Whale Tail 2022 Annual Open Pit Geomechanical Inspection

March 17, 2023

RE: Meadowbank Complex - Amaruq Site - 2022 Annual Open Pit Geomechanical Inspection

2022 Annual Open Pit Geomechanical Inspection

Observations - Phase 2 Southeast Wall (3)

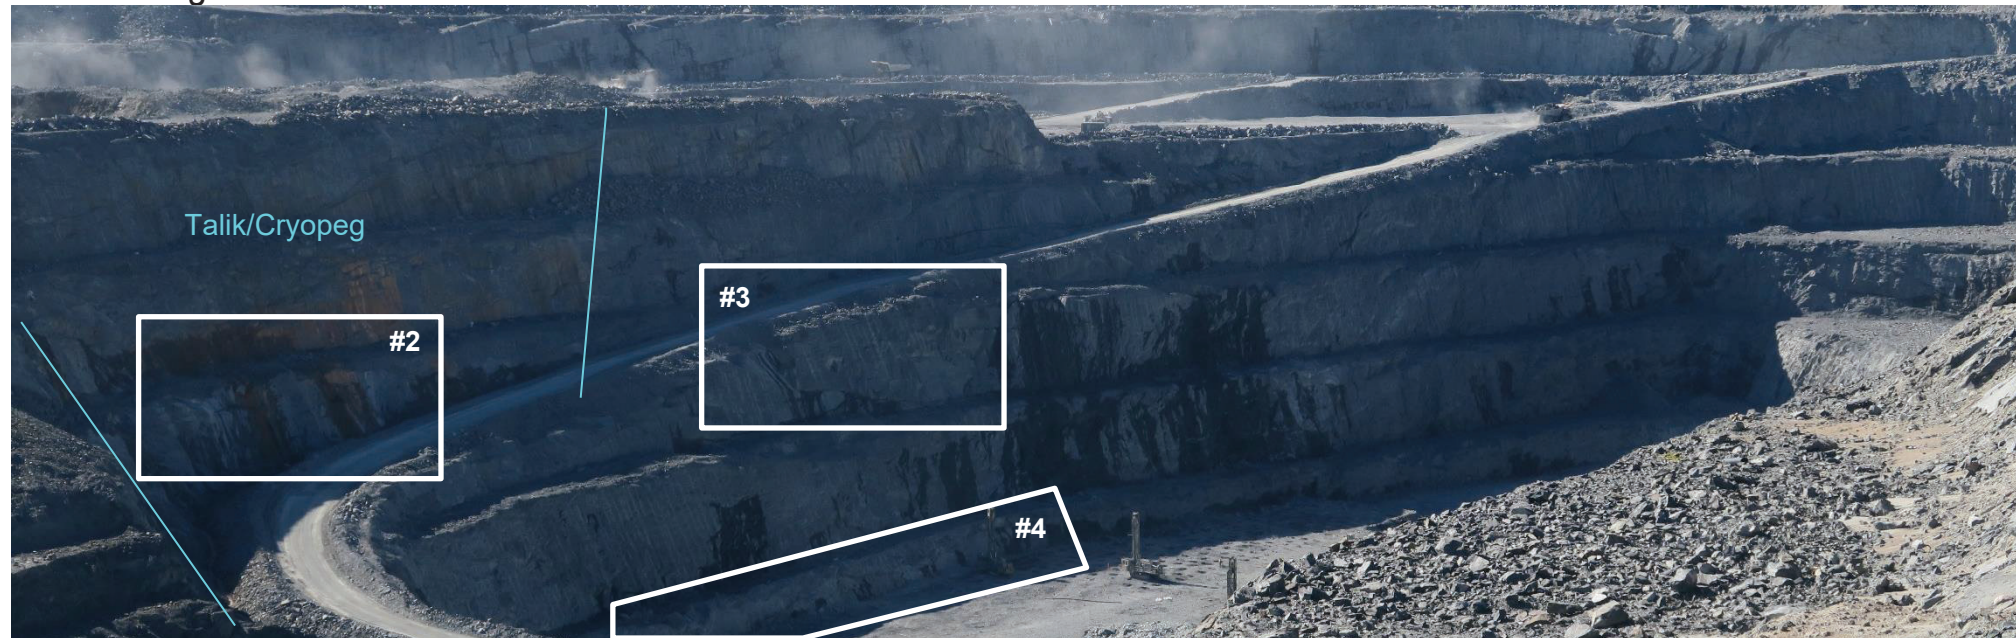
- A Brittle Structure was observed at the western end of the wall, adjacent the Phase 2 ramp.
- This structure (#3) is modelled along the northern contact of the South Limb Komatiite. The observed position, orientation, and thickness of the structure agree well with the 3D structural model.
- No particular stability concerns were noted.
- In general, the 3D structural model has not been validated against the exposures in the open pit. Recommend doing so to build confidence in the model as it is being used to inform key design decisions.

Observations - Phase 2 South Wall (2)

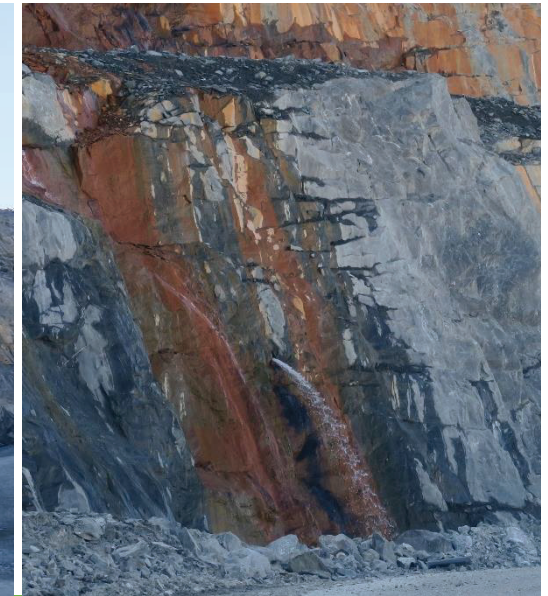
1. Spillover from the Phase 3 pushback has accumulated on the catch benches above the Phase 1 ramp and has previously blocked the ramp. The mine has limited the ramp to light vehicles and has partially constructed a rockfall berm along the inside of the ramp. The berm needs to be extended along the full length of the ramp and built up to ensure a consistent 2 m height (left photo). Some rockfall has accumulated behind the berm and it will need to be regularly inspected and maintained.

2. Prominent seeps are present in the lower South Wall, concentrated along sub-horizontal structures (centre photo). The seepage resulted in an ice wall but no significant ice falls occurred and the mine was able to manage this successfully. A water-management pushback has been planned to help mitigate this risk, which is endorsed. A test horizontal drain hole was completed (right photo) and has both consistently made water (including over the winter) and influenced the seeps on the wall. This suggests that horizontal drains may be viable in intercepting and managing seepage.

Observations - Northwest Wall

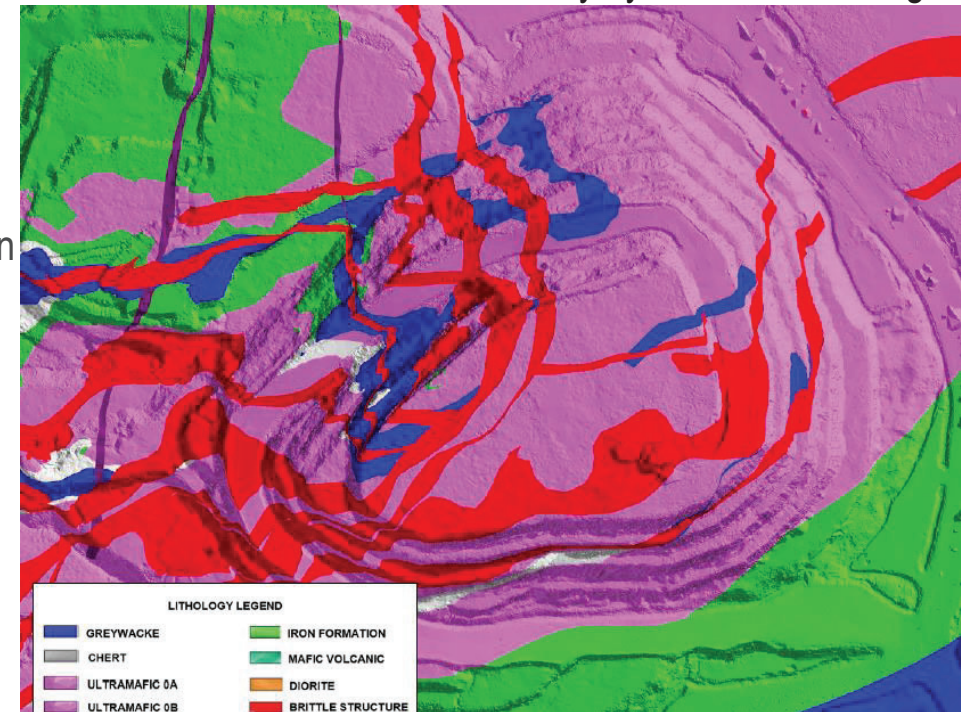
- The benches at the southern end of the upper wall failed back to the foliation during development. In some cases, there is effectively no catch bench width remaining.
- Mining of the IVR V2 open pit has resulted in spillover onto the northwest wall. The mine has adjusted the blasting practices to reduce this, but spillover is expected to continue.
- A rockfall berm has been established along the inside of the ramp and has capacity. The rockfall berm will need to be monitored and cleaned out as required as mining of IVR V2 continues.
- Mining of IVR V2 will ultimately remove the upper two to three benches of this wall, which will reduce the rockfall hazard in the long term.

Observations - Southeast Wall

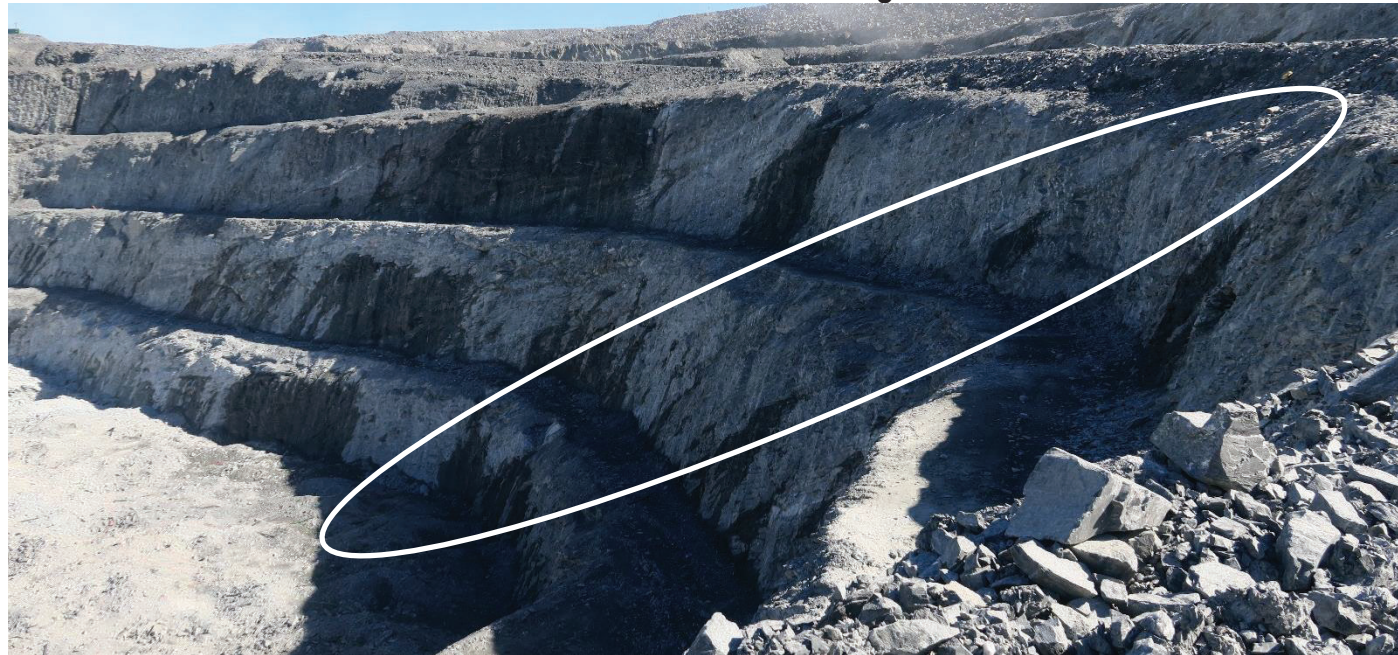
- Final wall in Design Sector V0C.
- The wall is performing well. Half barrels are visible and very little material is present on the catch benches.
- Several persistent cross-cutting features were identified during the 2021 inspection (examples circled below). These structures were not prominent in the structural data underlying the design of the open pit and there was a concern that they could impact the achievable slope geometry. It now appears that these structures were localized as they have not influenced the bench performance at depth.

Observations - General

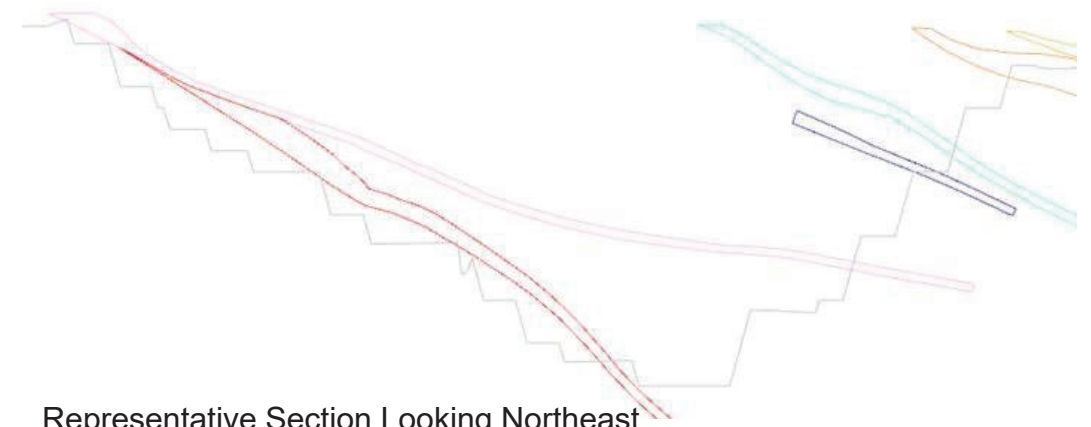
- The IVR V2 open pit is in the early stages of mining; approximately two benches have been established.
- These initial benches represent an important opportunity to validate the rock mass characterisation and slope geometry recommendations that underpin the open pit design. Recommend documenting the bench performance and key rock mass characteristics and comparing them to expectations.
- As noted earlier, managing spillover from the IVR V2 pit to the IVR V1 pit is an on-going challenge. The mine has adapted the blasting sequence to leave a small ridge adjacent the IVR V1 pit and then blasts the ridge into the V2 pit. This has been effective at reducing spillover.
- Comments on specific locations within the pit are provided on the following slides.

Observations - North Wall “Turtlehead”

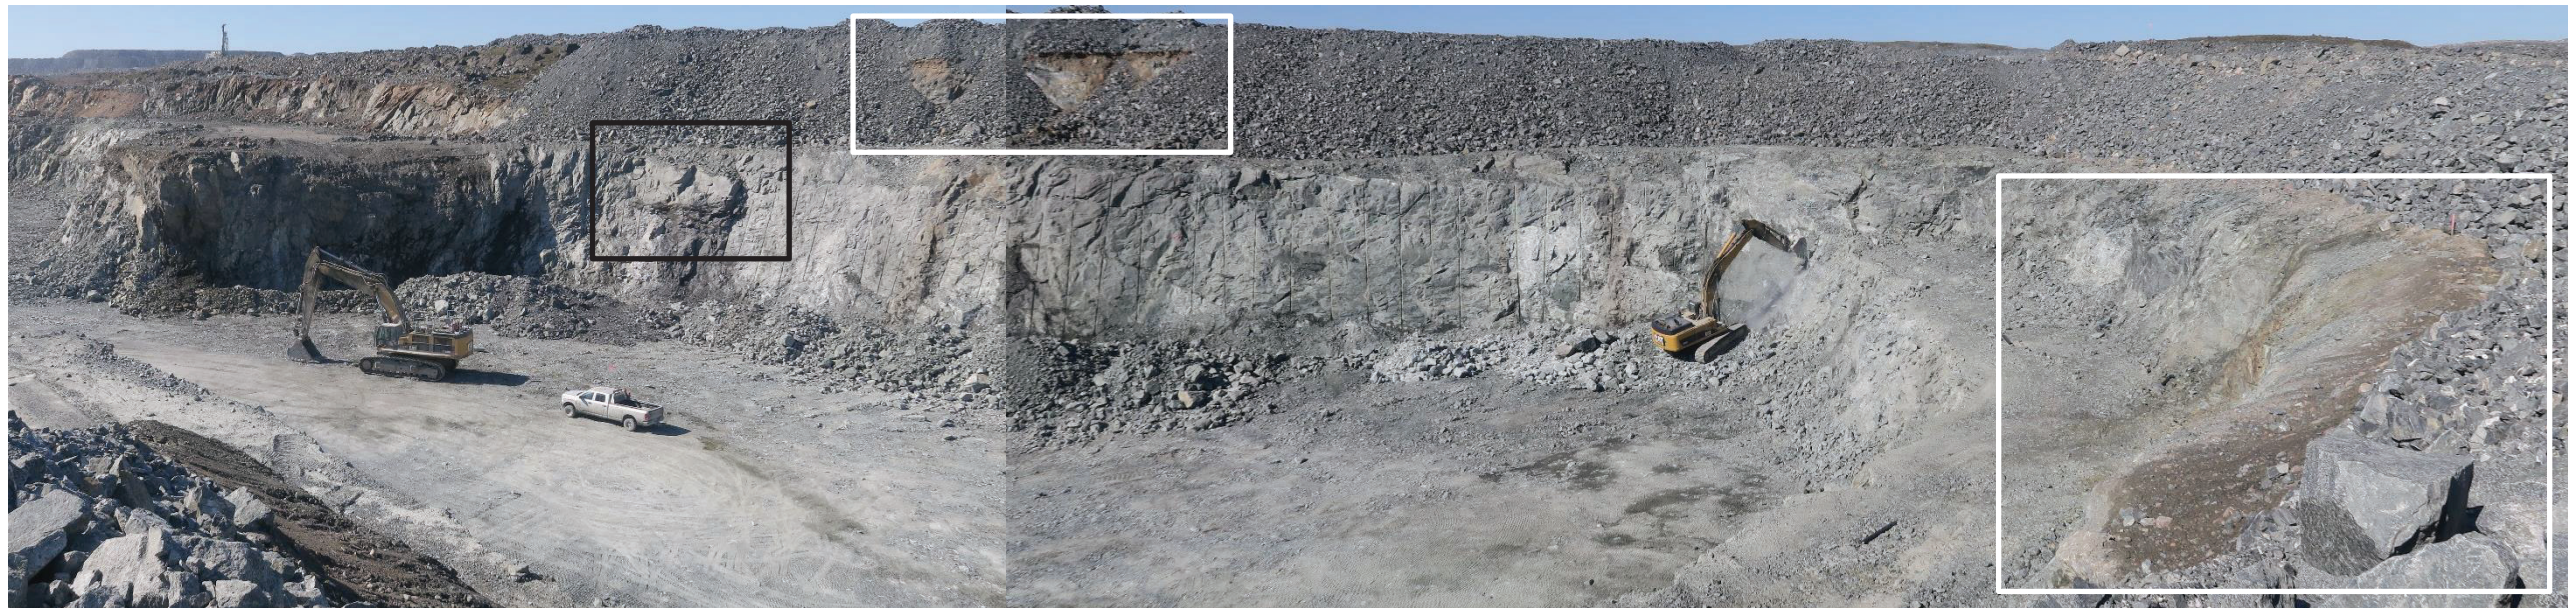
- The overburden in this area was thicker than expected, resulting in a large thermal cap. There are gaps in the thermal cap (outlined below in white) and exposed overburden is present along the crest of the upper bench. The overburden is likely to ravel over time. Section 1.135 of the Nunavut Mine Health and Safety Act requires unconsolidated material to be excavated back a minimum of 2 m from the crest. The thermal cap should be remediated in this area.

- Scaling of the end wall was in progress at the time of the inspection. Frequent hard toes were noted by the operator. The foliation is perpendicular to the wall in that area and significant scaling was required due to the presence of numerous small wedges/blocks. A potentially unstable block was observed on the wall (outlined below in black).

Hazard / Risk Assessment

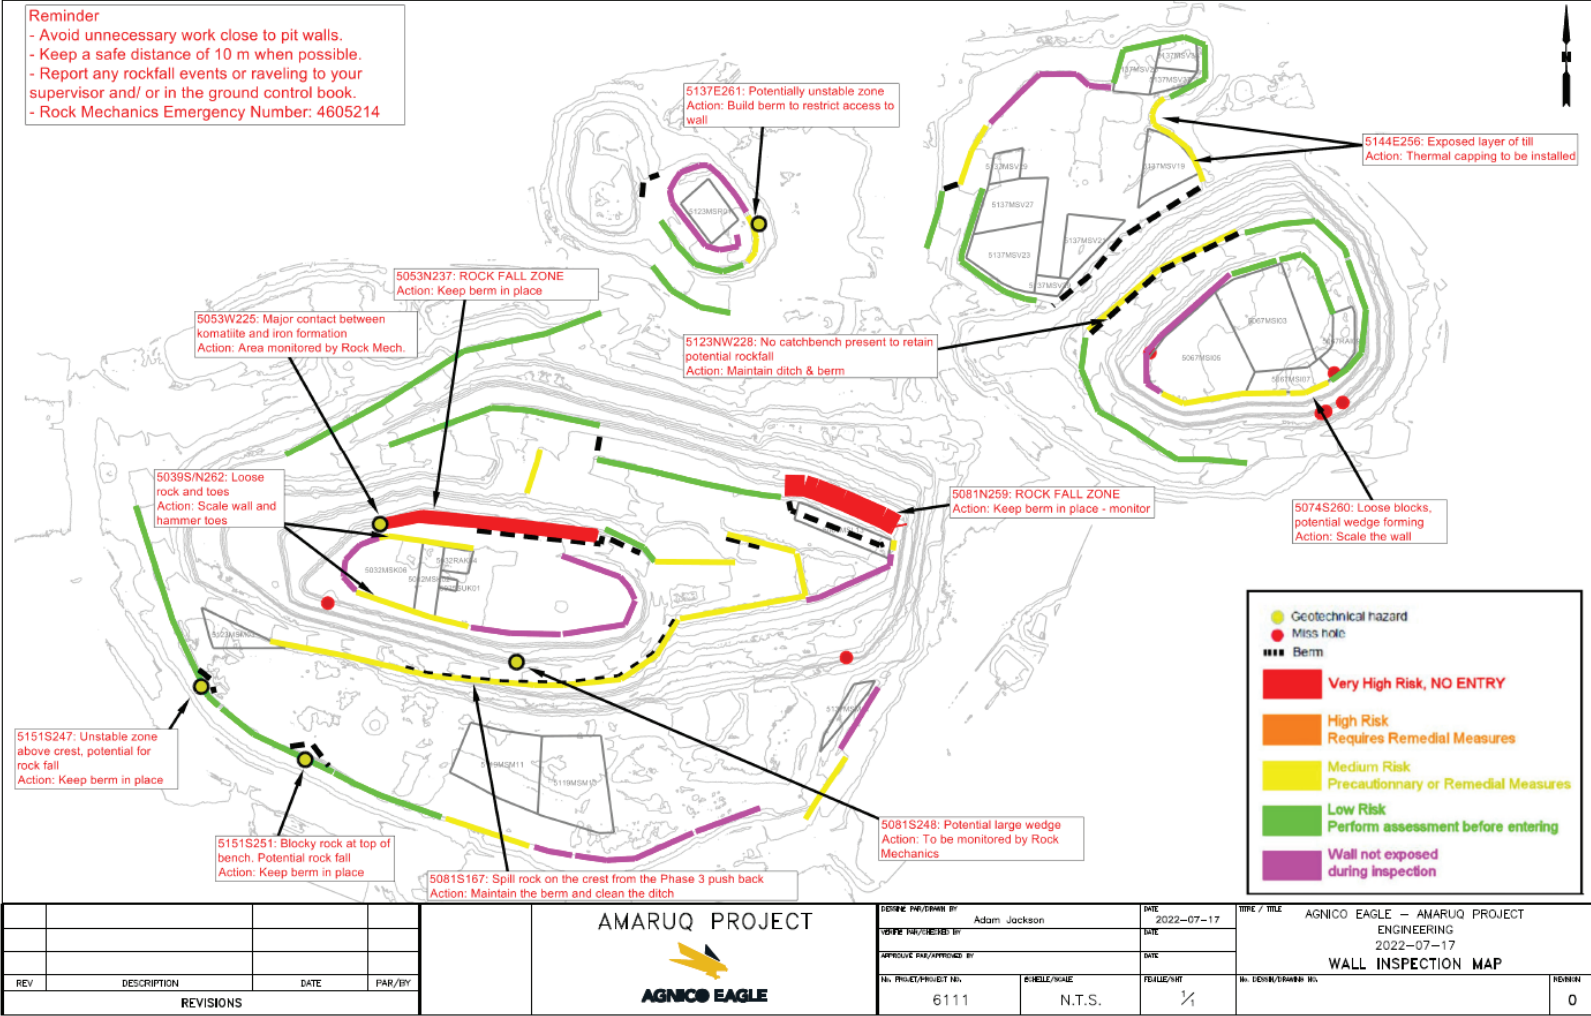
- Identified hazards and the required mitigation work are tracked on a Hazard Map available to the workforce. The map is an effective tool.
- There continues to be limited guidance on how to select the risk ratings. Recommend providing detailed guidance, including examples, on how to determine these ratings. The goal is to ensure that each member of the Rock Mechanics team can perform the assessment in a consistent and reliable manner.
- The map is updated every two weeks. However, with multiple pits in progress it is often rapidly out of date. Recommend issuing an update weekly (or more frequently) if there are notable changes. One possibility would be to issue a brief supplement that focuses solely on what has changed.

- Provide refresher training on the Work Close to Pit Wall procedure.
 - Refine the legend on the hazard map to clearly note the restrictions associated with the risk ratings (e.g., Yellow - Spotter Required).

SSR Monitoring - Alarms

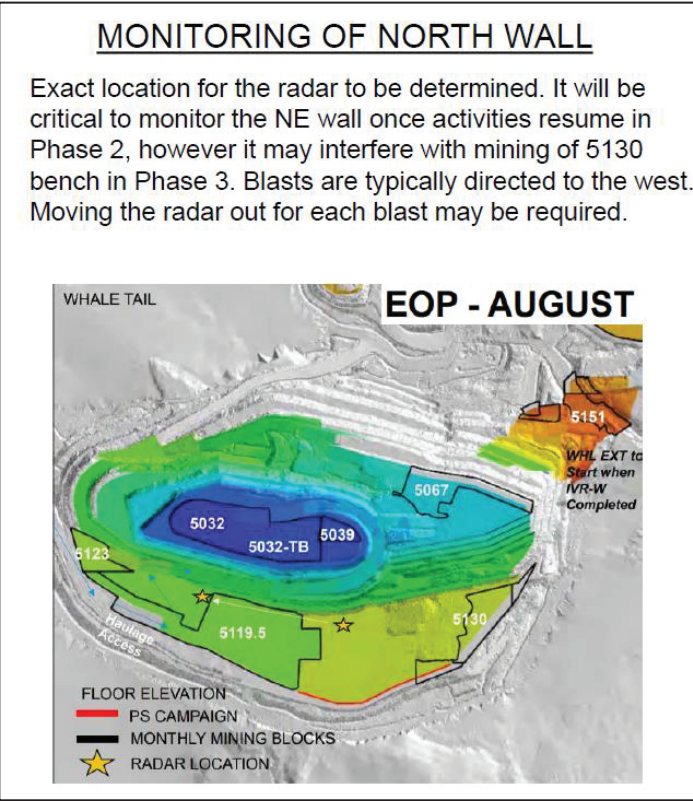
- The current Orange alarm thresholds are as follows:
 - Velocity exceeding 1.3 mm/hr with a calculation period of 180 minutes
 - 3 contiguous pixels over 2 consecutive scans

- Red alarms are not used. The Orange alarms are adjusted on an informal basis in response to observed conditions. For example, a lower deformation threshold may be used for an area of concern at a low angle of incidence. Additional parameters (e.g., coherence, inverse velocity) are used to interpret the observed movement on a case-by-case basis but are not incorporated into the alarms.

- The strategy of using Orange alarms and adjusting the alarm parameters on a case-by-case basis relies on an experienced operator who is familiar with the historical slope performance and is comfortable interpreting the data. The mine has recently developed a procedure for using the radar, including the process of setting alarms. This is a useful reference and particularly important given the number of new staff joining the Rock Mechanics team. However, neither the procedure nor the GCMP explain why the alarms have been set at their current values or provide guidance on how they can be adjusted based on different circumstances. While it is recognized that it is not practical to cover all eventualities, recommend providing additional guidance on how to define alarm criteria.
